STATE OF WASHINGTON
DEPARTMENT OF ECOLOGY

Re: Further Action at the following Site:

- **Site Name:** Gibraltar Senior Living
- **Site Address:** 10816 18th Ave E, Tacoma, Pierce County, WA 98445
- **Facility/Site No.:** 6607
- **Cleanup Site No.:** 12686
- **VCP Project No.:** SW1472

The Washington State Department of Ecology (Ecology) received your request for an opinion on your independent cleanup of the Gibraltar Senior Living facility (Site). This letter provides our opinion. We are providing this opinion under the authority of the Model Toxics Control Act (MTCA), Chapter 70.105D RCW.

Figure 1

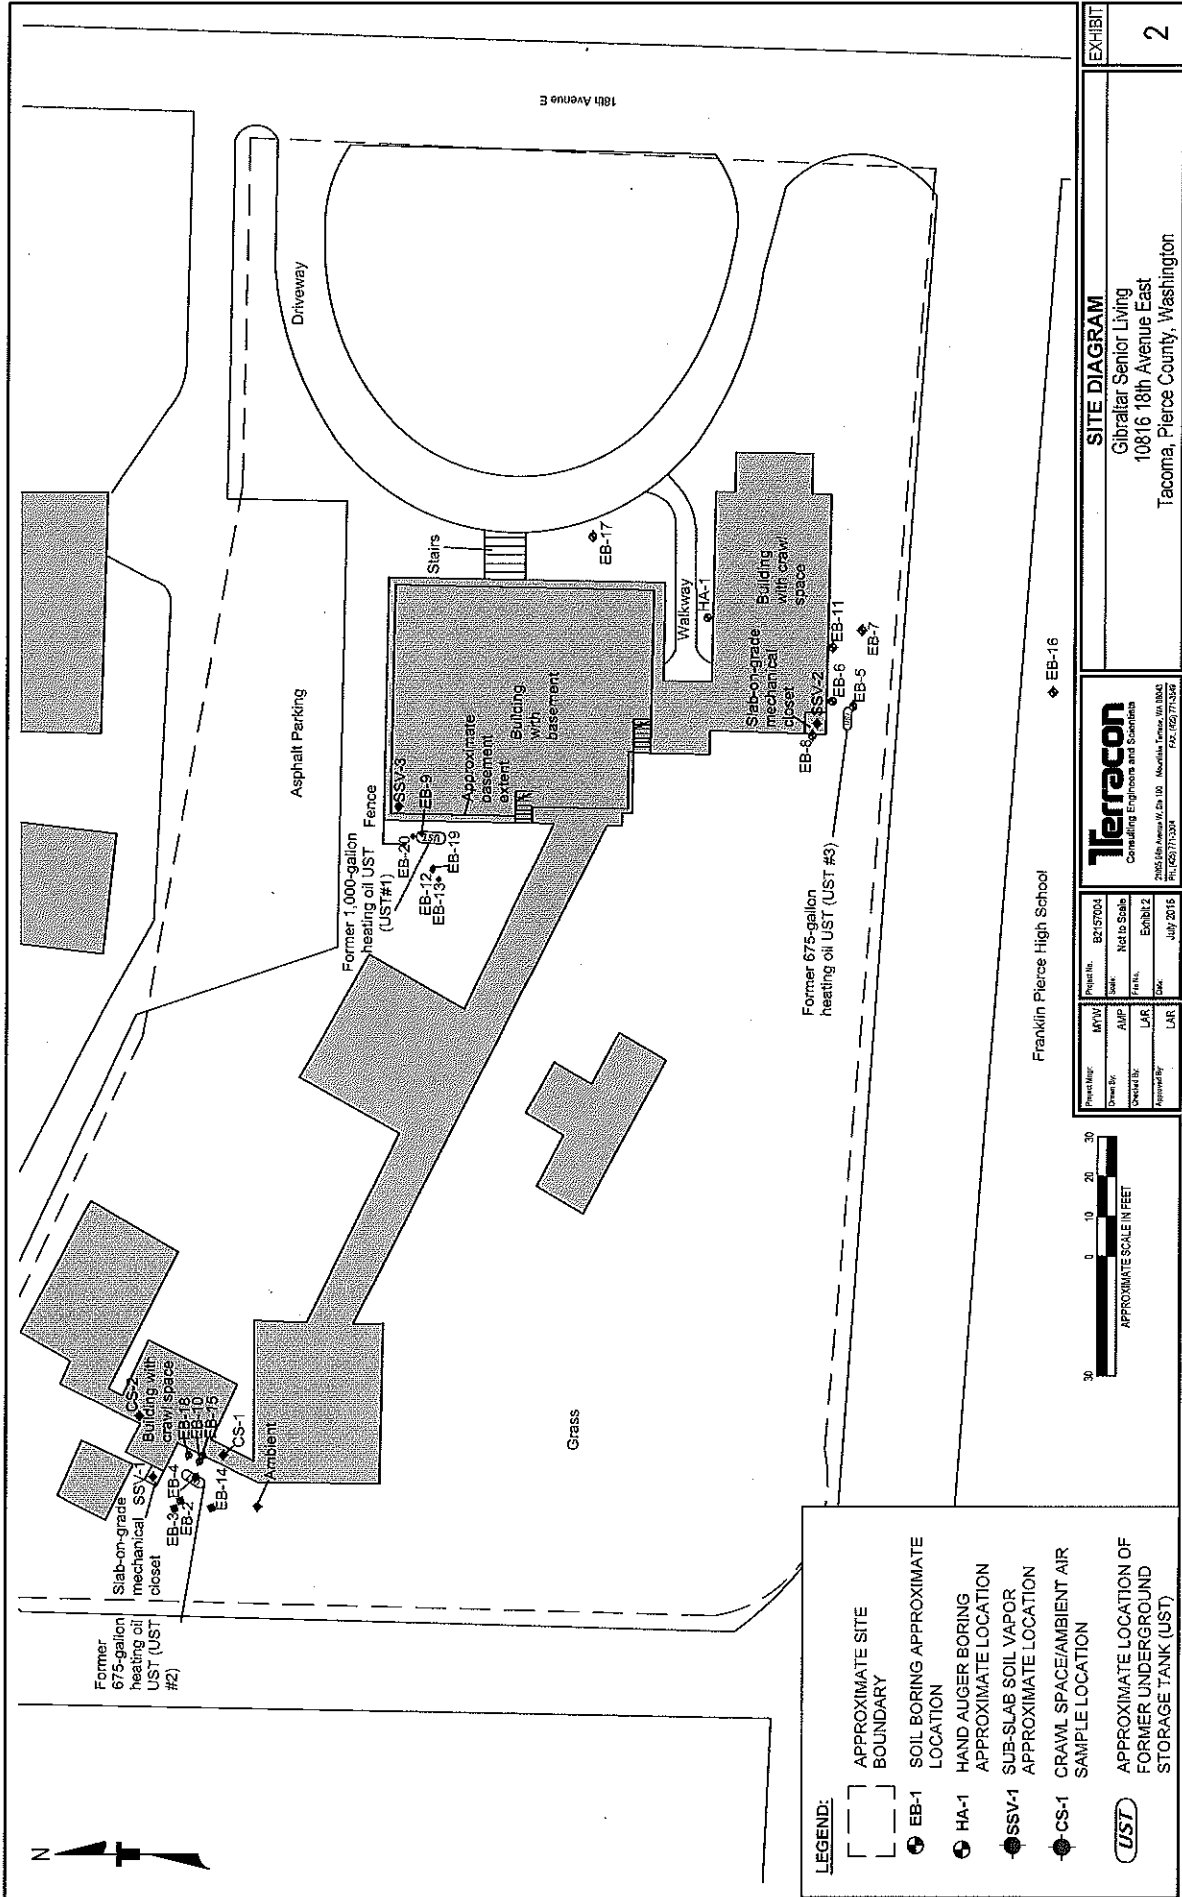
- This memorandum limits discussion of Site contamination to the off-Property diesel and heavy oil concentrations in groundwater collected from boring EB-16 (Figure 1).

- 11) **In order to determine if the concentrations of diesel and heavy oil exceeding the MTCA Method A cleanup levels at EB-16 are attributable to the release at the Site or the result of a contaminant plume encroaching upon the Site from another release, Ecology recommends the following:**

- a. Install a second monitoring well to the south of former soil sample location "V", but still within or at the Property boundary, if possible. However, Ecology acknowledges that utility conflicts may result in the well being installed slightly off-Property.

- a. Specific to this Site, Gibraltar Senior Living may start by installing one monitoring well at the former soil boring location EB-16. If groundwater sampling analytical results indicate that no concentrations exceed the applicable MTCA cleanup level, then no additional well installation would be necessary.

- e. Ecology recommends following all access agreements and utility clearance requirements prior to well installation.
- 12) **If concentrations in the well installed at EB-16 exceed the MTCA Method A cleanup levels, then Ecology recommends the following:**
